Submission

Macedon Ranges draft Landscape Assessment (Study) – October 2018

29/11/18

Figure 1 Extent of the Assessment's landscape protection

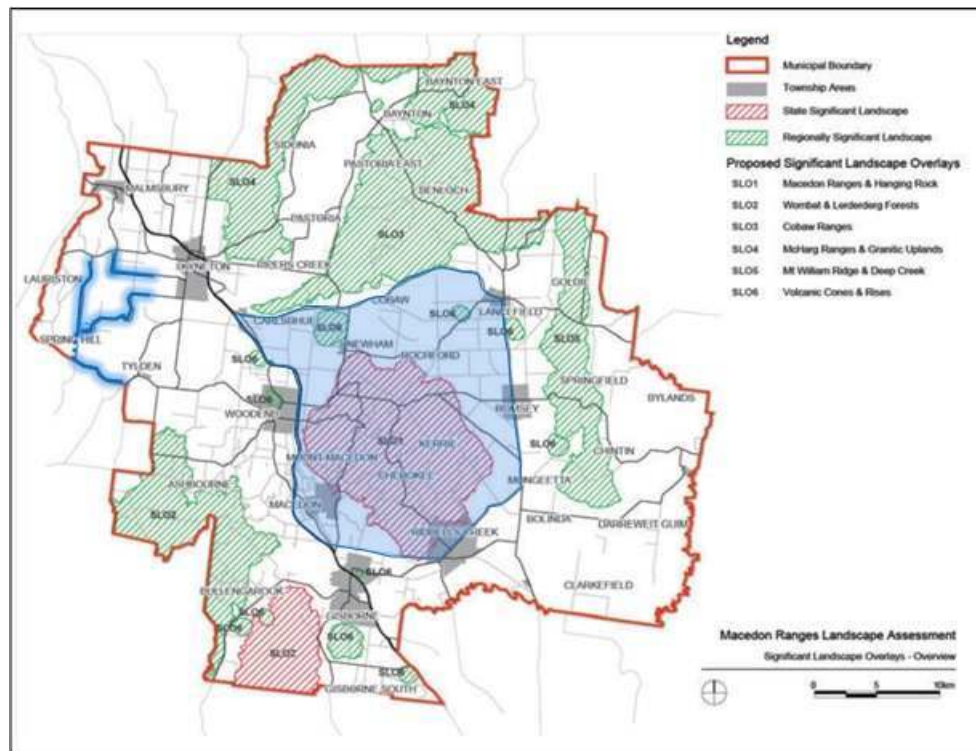
Overlays are proposed for landscapes determined to be significant at State (**Red**) and Regional (**Green**) level.

Blue indicates the ‘central block’ area loosely subject to the Assessment’s proposed *“Protection of significant views from road corridors”* policy. Within this area, however, the policy would only apply to those parts zoned RCZ2 and RCZ5. Where applied, the new policy only sets requirements for development which needs a permit within 100 metres of a road, and only if it could potentially “block” views to Mt. Macedon, Hanging Rock and the Jim Jim, and the Lauriston and Coliban (should be Upper Coliban) Reservoirs.

New Significant Landscape Overlays only require consideration of impacts *adjacent* or *immediately adjacent* to (some) roadsides, and/or impacts on views from specific viewing locations. A view is significant only if it includes a view of a State or Regionally significant ‘landscape’ (i.e. a landscape feature).

Figure 2

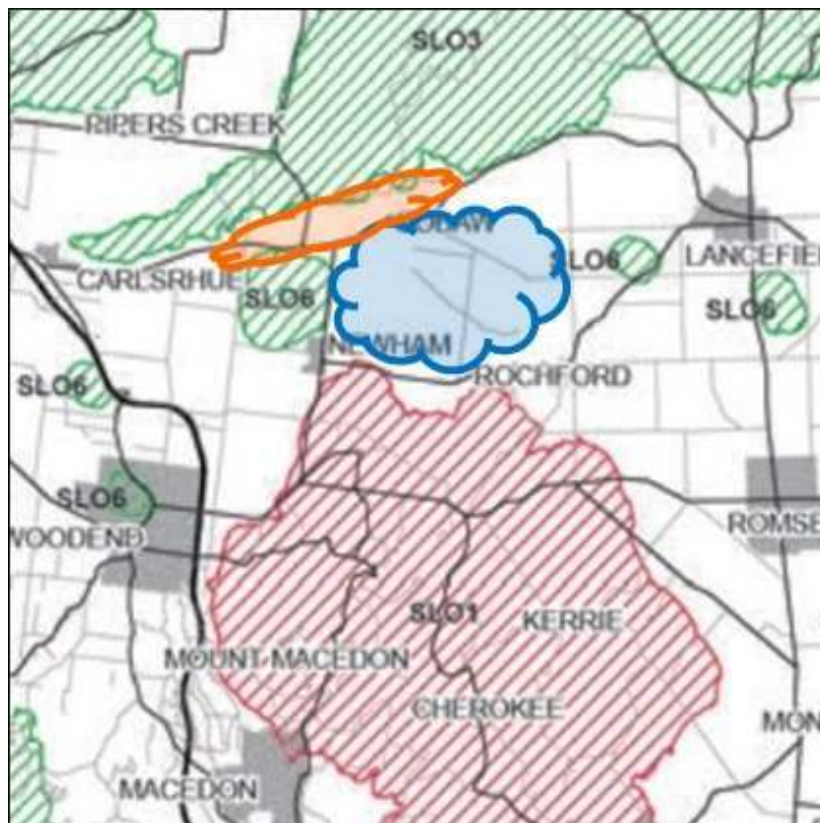
At page 22R, the Assessment says SLO1 applies to landscape areas 1.4 Macedon Ranges and 1.5 Newham Rises, but SLO1 doesn't cover all of the Newham Rises Landscape Area. The 'gap' area (shown as **blue** on Figure 2) is subject only to the proposed Local Policy "*Protection of Significant Views from Road Corridors*".

North of Three Chain Road, between that road and the start of SLO3 further north, is another "gap" where neither SLO nor policy is proposed for this landscape of primary importance (shown as **orange** on Figure 2).

Blue area - no SLO between the vicinity of Hanging Rock and Three Chain Road.
 Orange area - 'gap' between Three Chain Road and commencement of SLO3
 where neither overlay nor policy apply.

Figure 3

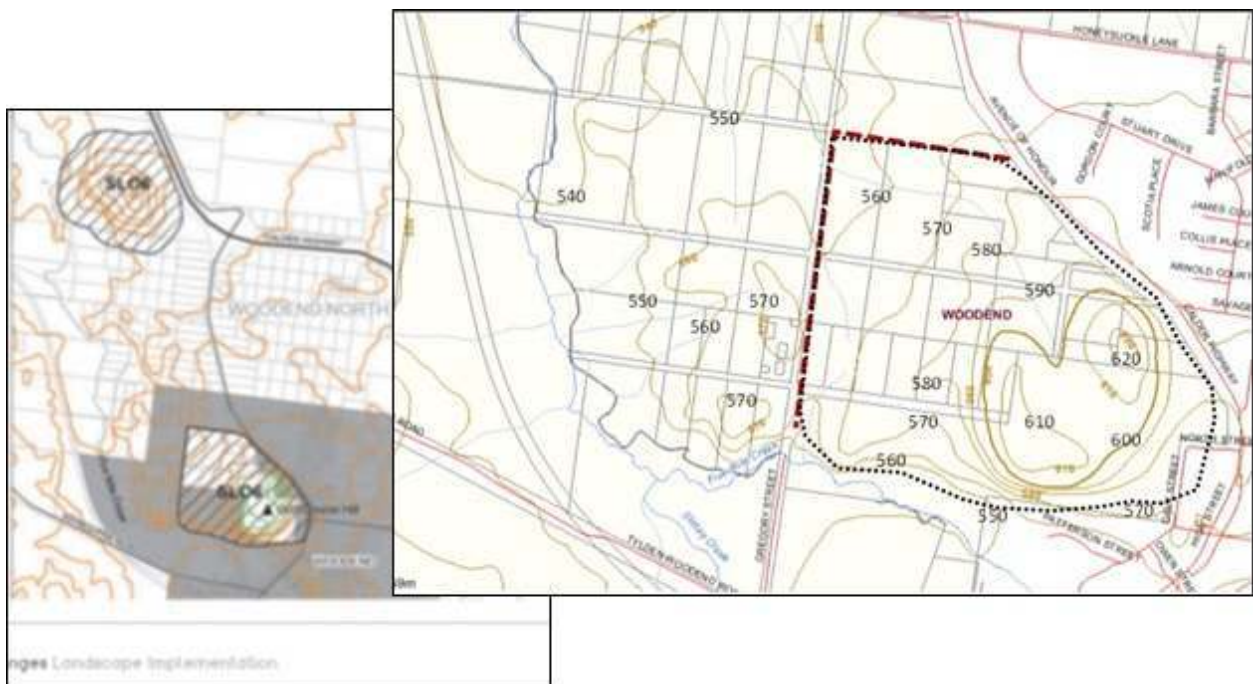
Application of SLO6 to most other 'cones' is based upon a 1:5 ratio (i.e. an overlay 5 times the height used to reflect both the feature and its setting), but not Golf Course Hill. The proposed overlay instead extends to base of slope only on the southern and eastern sides, and does not change to the north or west, where it remains based on title boundaries, as now.

- the Assessment's conclusions, which focus solely on the Hill's importance to the northern gateway location (ignoring the western Tylden Road gateway), or
- the proposed SLO, which only covers half of the hill and, although claiming SLOs are applied regardless of land tenure, studiously avoids extending the overlay west and north on "Villawood" land by retaining the existing overlay's western and northern boundaries (based on title boundaries) unchanged.

The Assessment, at Page 45R, goes so far as to claim the rural setting of the volcanic **to the north and its contribution to significance has been retained within SLO boundaries.**

- (a) Left: Proposed SLO6 (hatched) expanded into grey area to the east and south only (page 49S) and
 (b) Right: Existing overlay boundaries (red dashed line) unchanged; remaining hill left outside SLO6 (black dotted line)

Figure 5 Page 36S – the yellow line is the existing SLO1, the red dashed line is the proposed SLO4

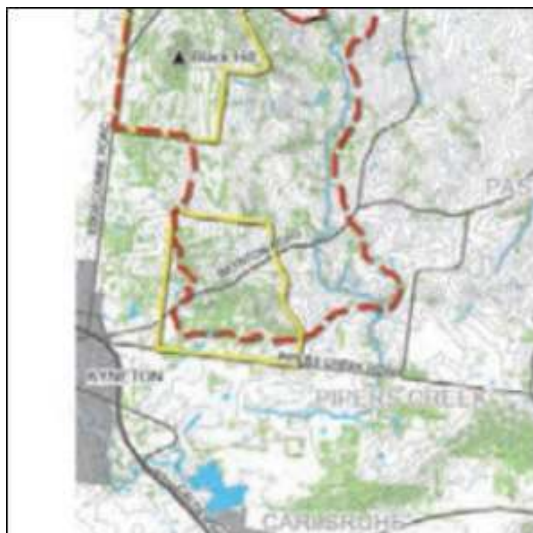
The Assessment notes, at SLO4 McHarg Ranges and Granitic Uplands Page 36R, that the proposed SLO currently applied to the “Baynton Road granite hills” (i.e. Bald Hill) area is retracted slightly, based on topography and significance extent. As this cleared, generally undeveloped area with views to the hills is very exposed from Pipers Creek Road, it is not clear why this area no longer warrants landscape overlay protection.

Figure 6

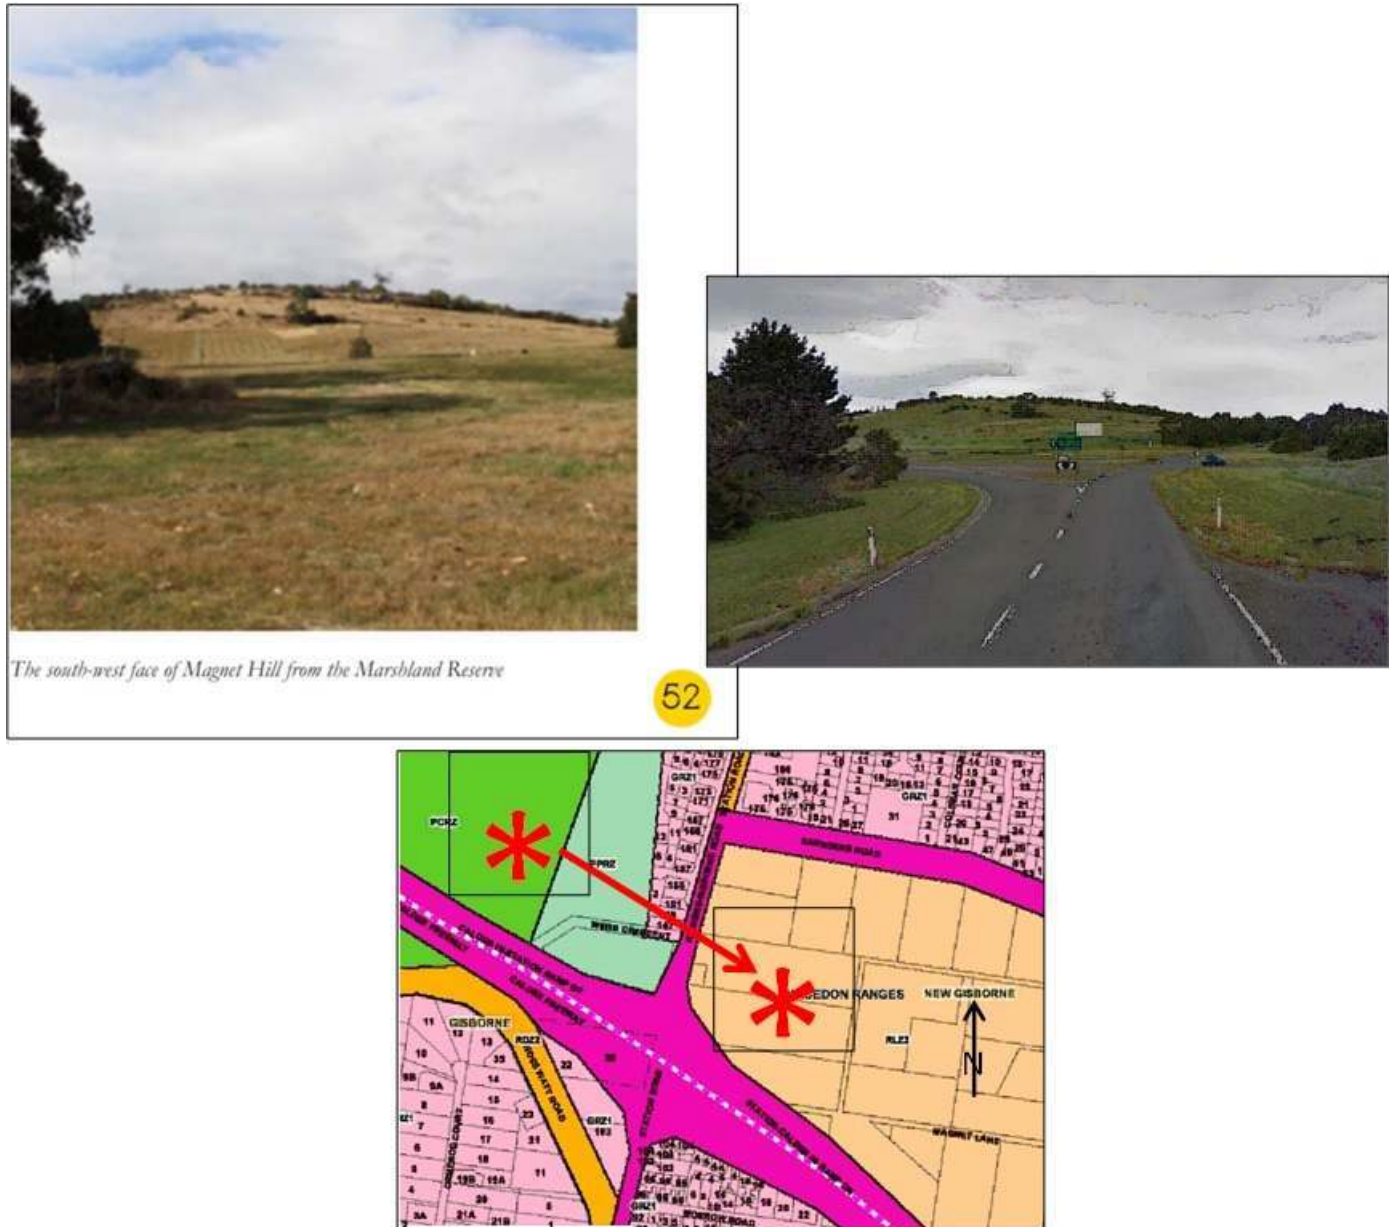
The Assessment refers throughout to the “south western face” of Magnet Hill, when it is the north western face (Figure 6).

(Top left) Image from the draft Landscape Assessment of the “south western face” (Page 52S);

(Below) Planning scheme Map 36: the view from the Gisborne Marshlands is to the north western face of Magnet Hill.

Figure 8 Extent of SLO6 applied to Mt. Gisborne, and exclusion of associated cone

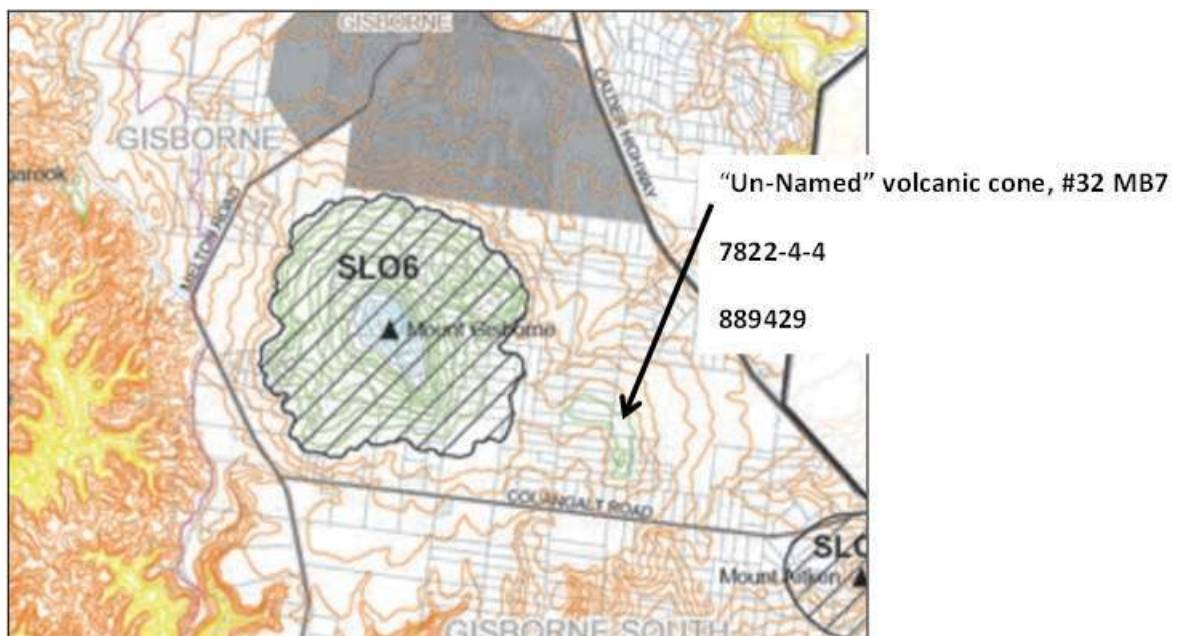
The assessment makes the following recommendation, at 2.2 Mt. Gisborne, Page 15S:

- *Recommendation - SLO boundaries should encompass the entire volcanic feature based on topography, with consideration of break of slope, visibility and views.*

The SLO6 proposed for Mt. Gisborne takes a narrow view of landscape and excludes an associated identified volcanic cone and high point (Figure 8), which is above 600m in height, with clear synergies with Mt. Gisborne (630m above sea level). This is a minimalist approach to landscape protection, and is not fulfilling criteria for applying the overlay.
